# Net Zero Teesside Project

The Net Zero Teesside Order

Notification of Proposed Changes to the Net Zero Teesside DCO Application

Date: 18 February 2022

TITLE  
 NOTIFICATION OF PROPOSED CHANGES  
 OVERVIEW

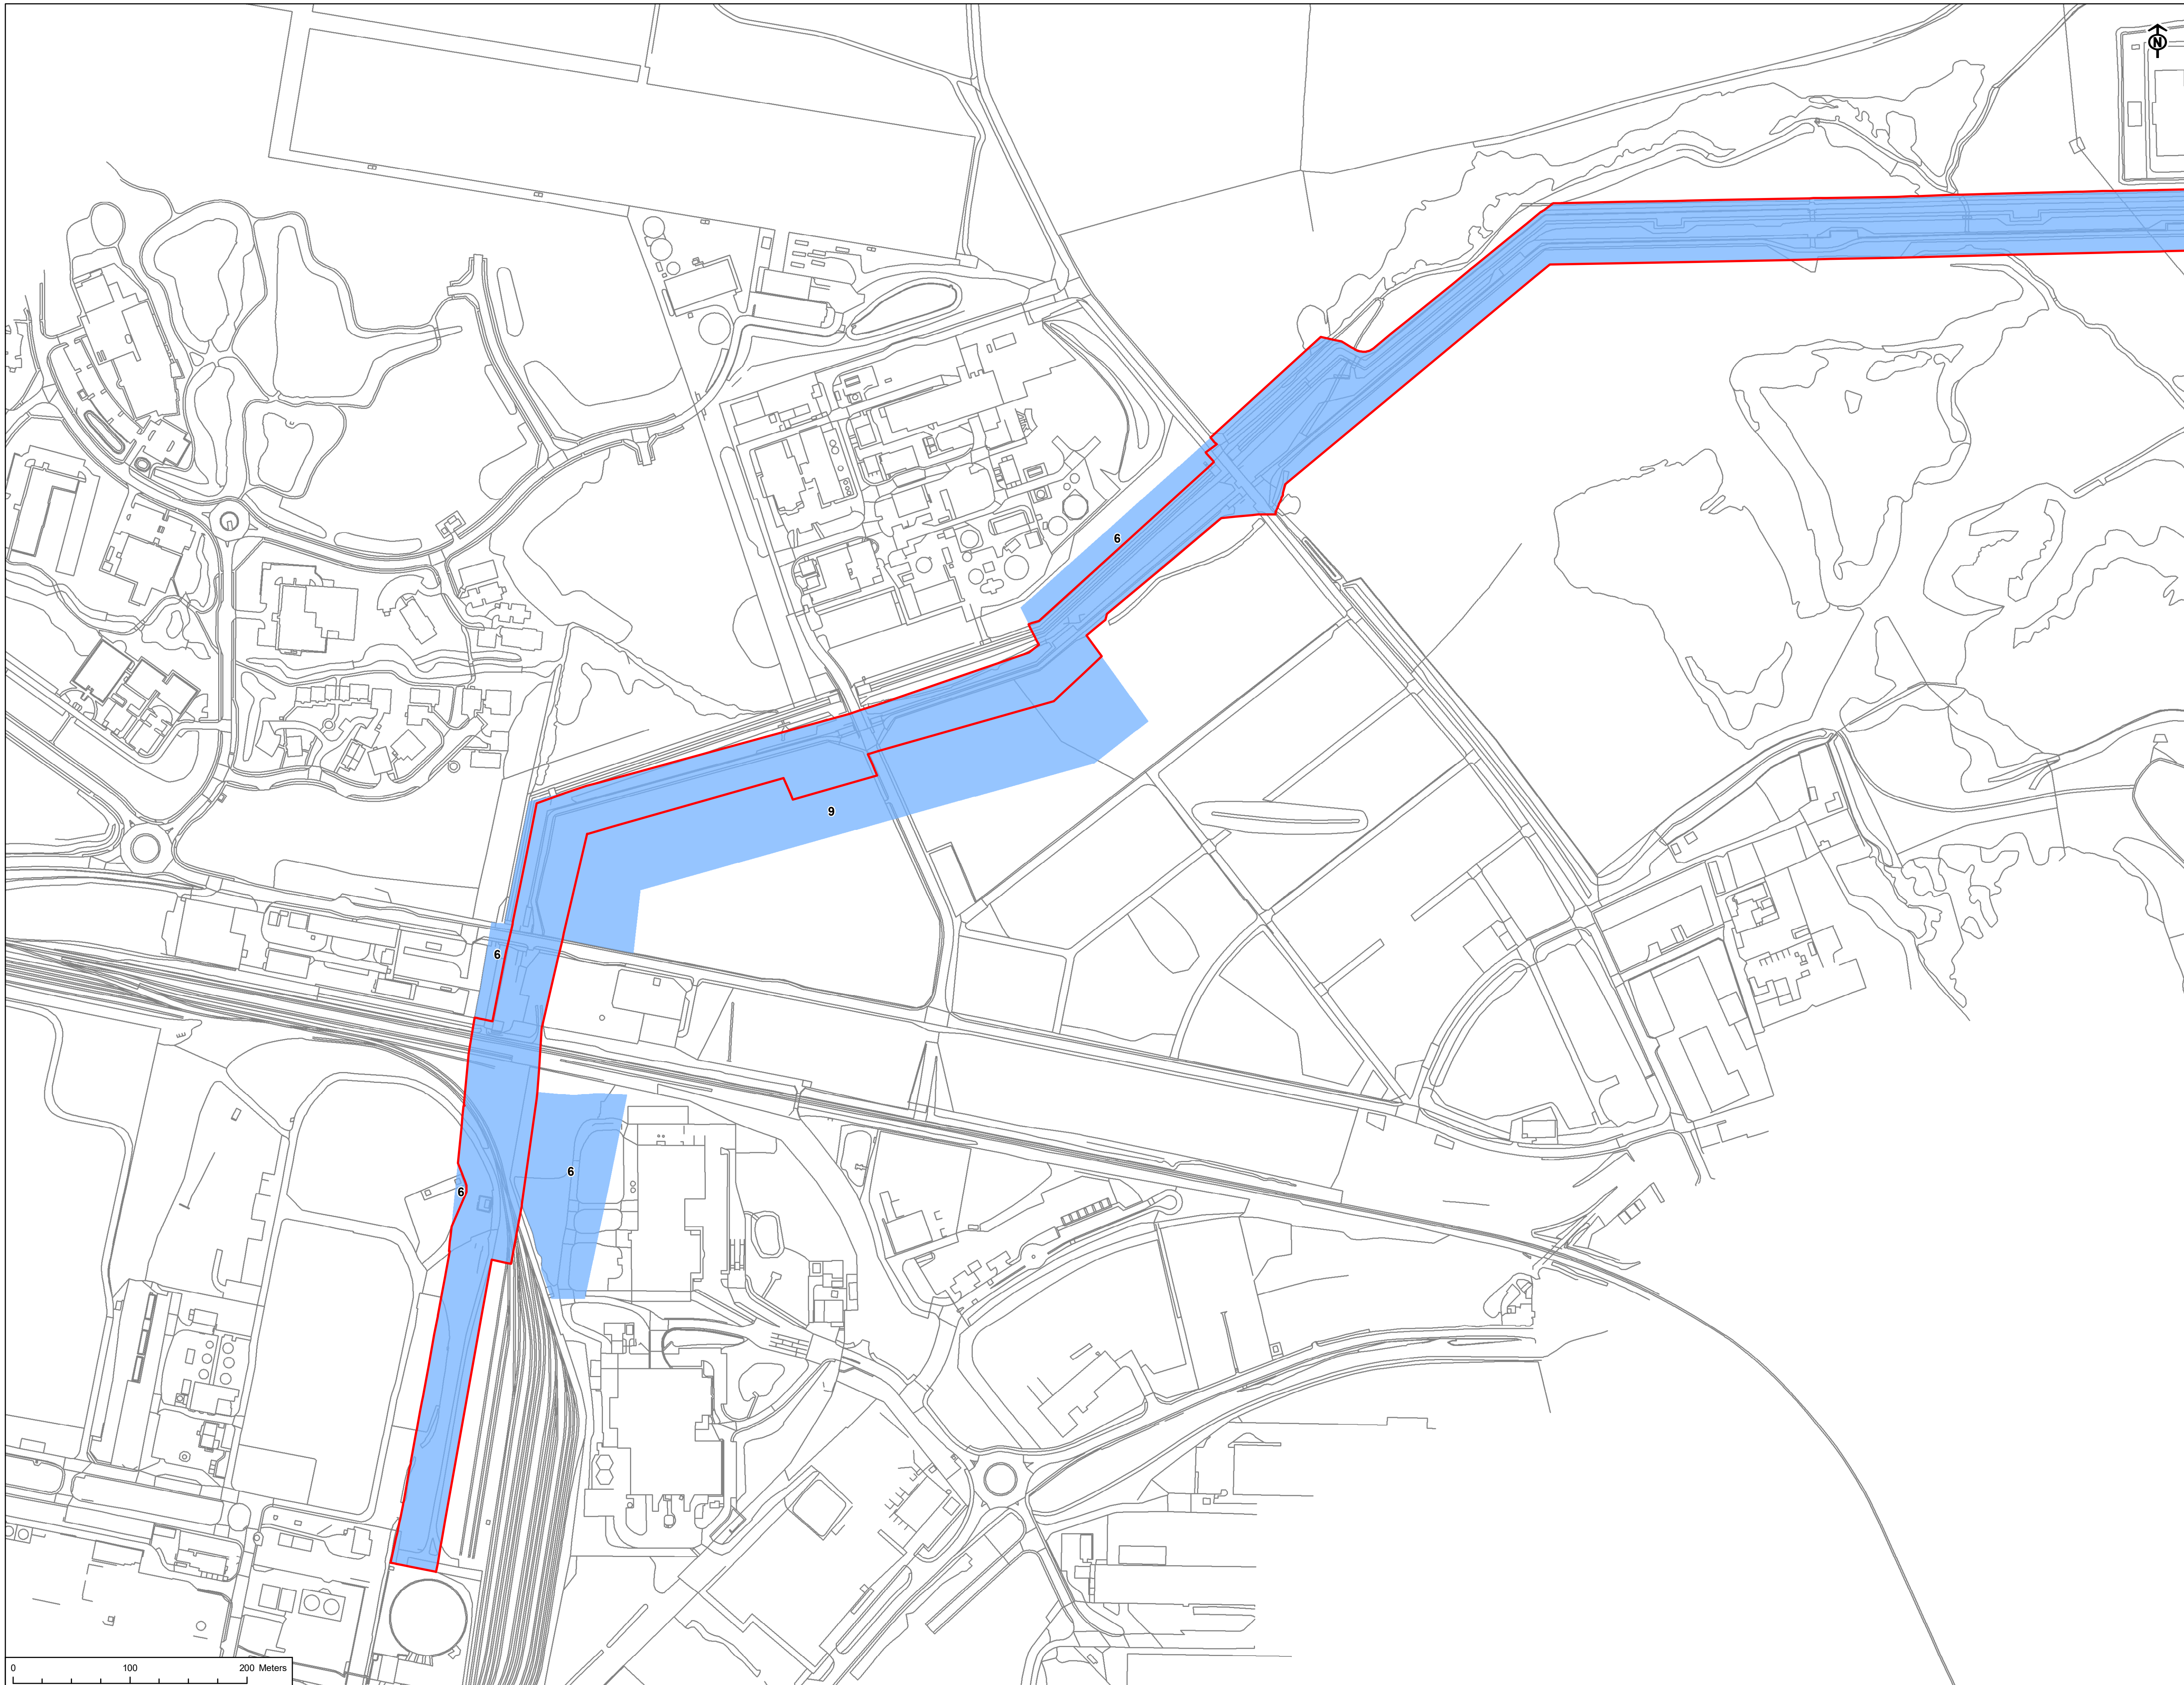
- 2.4.8 The proposed changes are explained in more detail below. The proposed updates to the Order Limits and the location of the proposed changes are shown on the plans at **Appendix A**. Those show the current Order Limits (as per the DCO Application submitted in July 2021) in blue shading, and the proposed updates to the Order Limits in red outline. An overview plan of the whole Order Limits is presented, followed by 14 sheets each showing the relevant part of the Order Limits in more detail.
